Tennessee Valley Authority, Post Office Box 2000, Spring City, Tennessee 37381

WATTS BAR NUCLEAR PLANT (WBN) UNITS 1 AND 2 - SUPPLEMENTAL INFORMATION ON  
THERMAL EVALUATION CRITERIA FOR STRUCTURAL STEEL MEMBERS (TAC No. M79717  
AND M80346)

Supplemental Information on Thermal Evaluation  
Criteria for Structural Steel Members

ENCLOSURE 1

Figure 11.6.1A

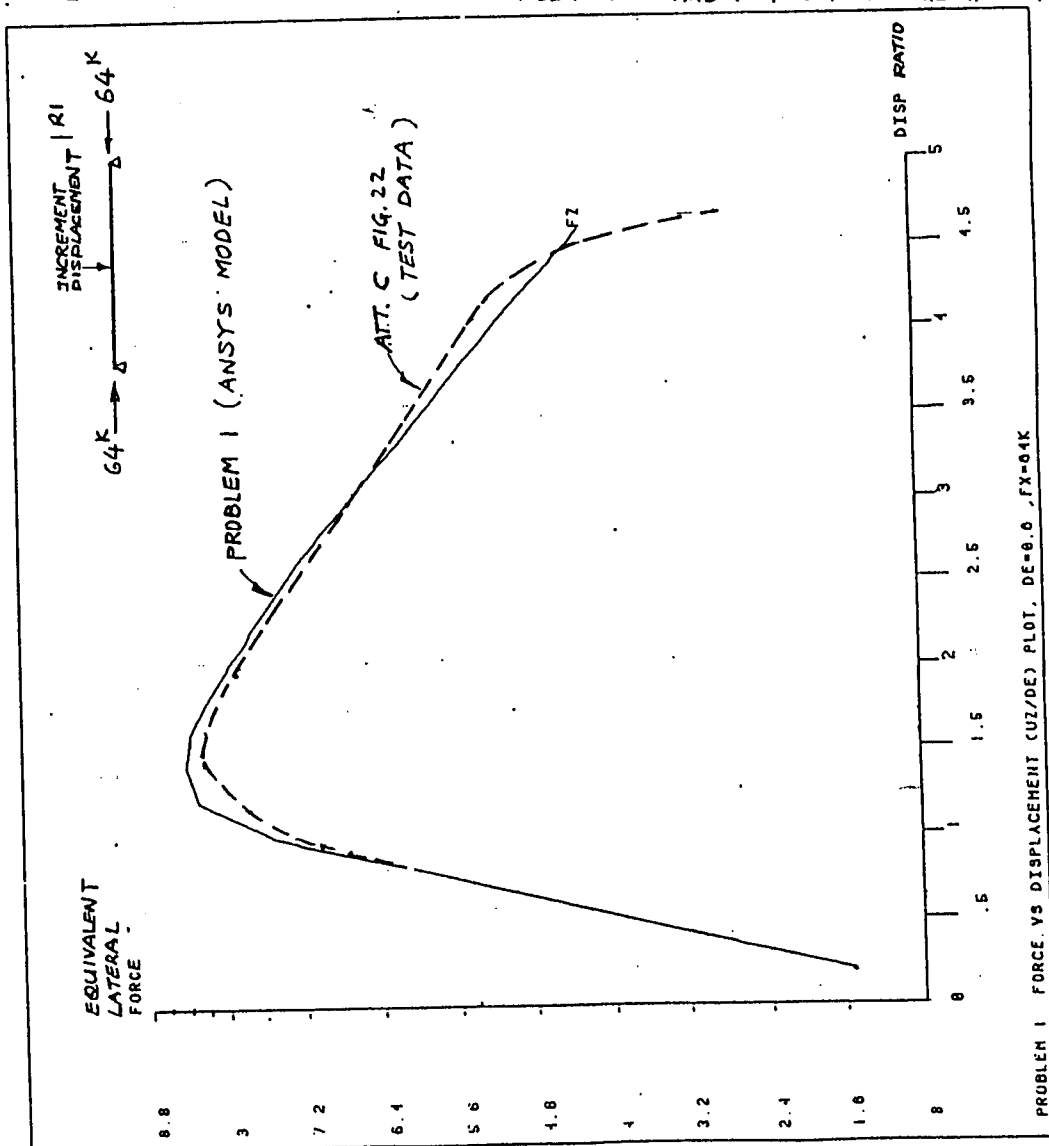
TVA should provide experimental data demonstrating that the proposed ductility ratio of three does not mean a state of imminent structural instability (collapse) due to lateral loading, and represents the maintenance of sufficient margin. The experimental data should include, as a minimum, the following parameters:

- a. beam-column effect,
- b. compatibility and comparability of transverse and axial loads tested to those of Watts Bar beams being evaluated,
- c. dynamic response due to safe-shutdown earthquake in a post-inelastic region, and
- d. combination of a. and c. above.

- ° Based on the comparison of load-deflection data, the ANSYS analysis results match very well with the test data. The comparison of results is provided in attachment 1.1.

- The test data showed that the specimen becomes unstable when subjected to an 8.2 kip lateral and 64 kip axial load (mechanical load). This was also predicted by the ANSYS analysis. The study also demonstrated that the structure is stable when the axial load is generated by the restrained thermal expansion. This is demonstrated in plots of the displacement ratio versus temperature and axial force versus temperature. These plots are provided in attachment 1.2. The plots show that initial yield for this problem occurs at 160 degrees and the peak axial reaction occurs at 200 degrees.

CLIENT \_\_\_\_\_  
PROJECT WBMP - UNIT 1  
SUBJECT ABAQUS VERSUS ANSYS COMPARISON

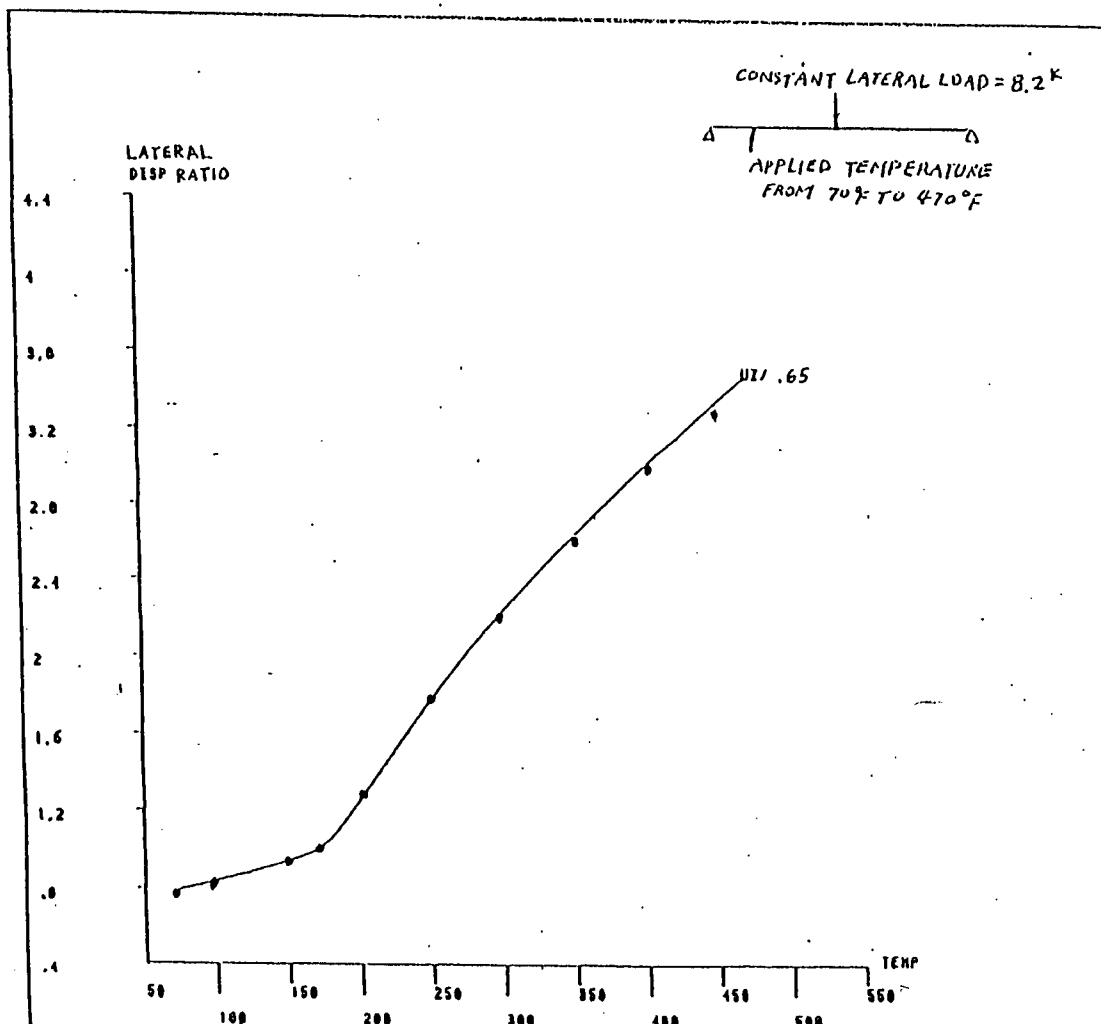
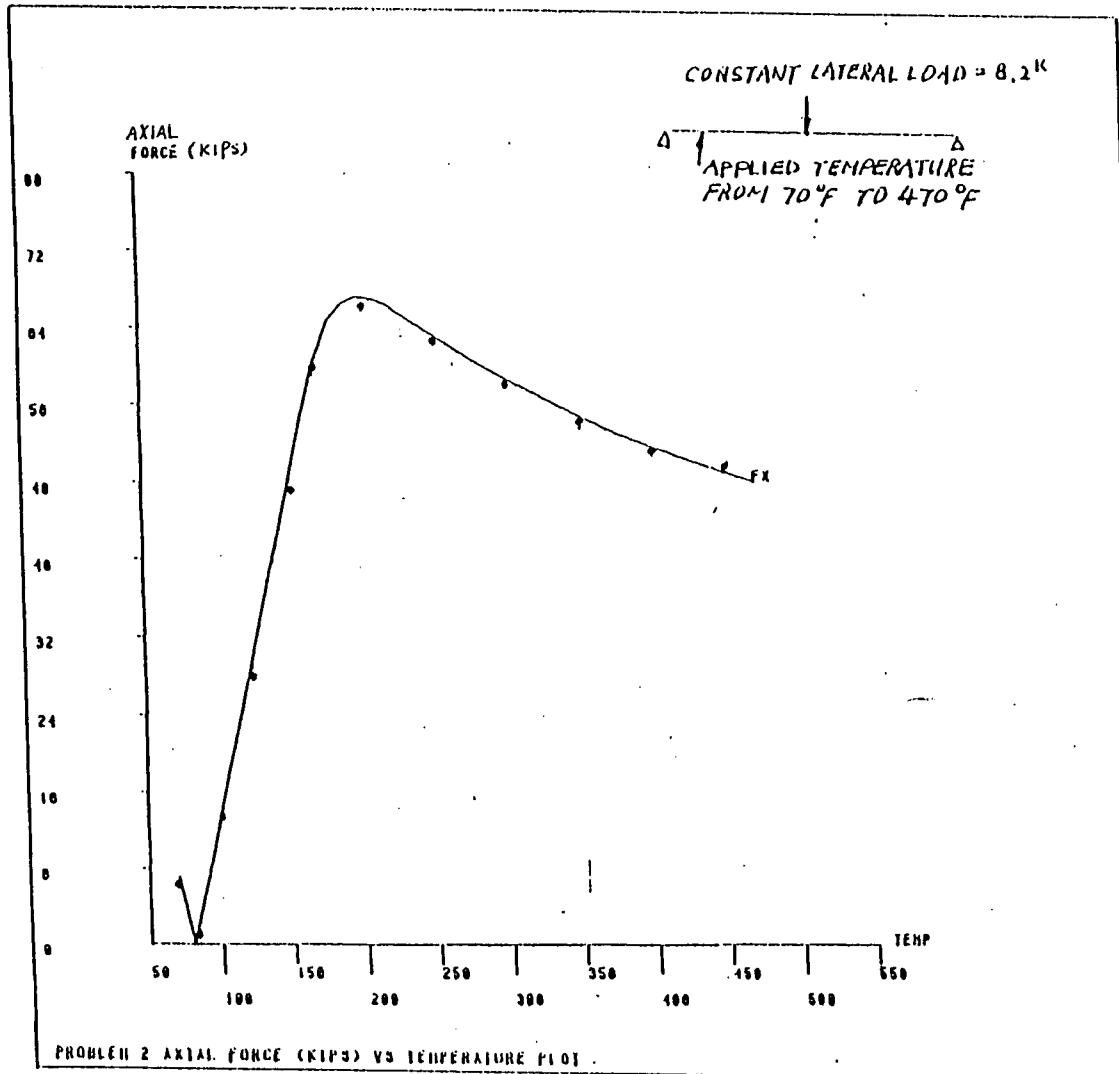
Since ANSYS code is the primary tool to calculate the ductility of a member as well as the extent of the thermal axial load relaxation, there should be a verification of the code based on applicable experiments in an inelastic region. This should include comparison of the ANSYS results with experiments performed in Concern 1, as well as numerical studies regarding error estimate and instability associated with the calculations.

To demonstrate independently that the ANSYS program is capable of determining the structural responses for the Watts Bar thermally restrained structures, a nonlinear analysis was performed using the ABAQUS program. The ABAQUS program is also a general purpose finite element computer program capable of solving linear and nonlinear problems. This program was developed by Hibbit, Karlsson & Sorensen, Inc. with support from EPRI. The problem chosen for this analysis is a simple supported beam subjected to a lateral mechanical load and followed by a temperature increase. This problem was previously analyzed by using the ANSYS program and documented in enclosure 2 reference 1.

The analysis results obtained from the ABAQUS run were compared with those from the ANSYS analysis. Attachment 2.3 shows the plots of the displacement ductility vs. temperature and beam axial force vs. temperature for results obtained from ANSYS and ABAQUS programs. The ABAQUS results match very well with the ANSYS results.
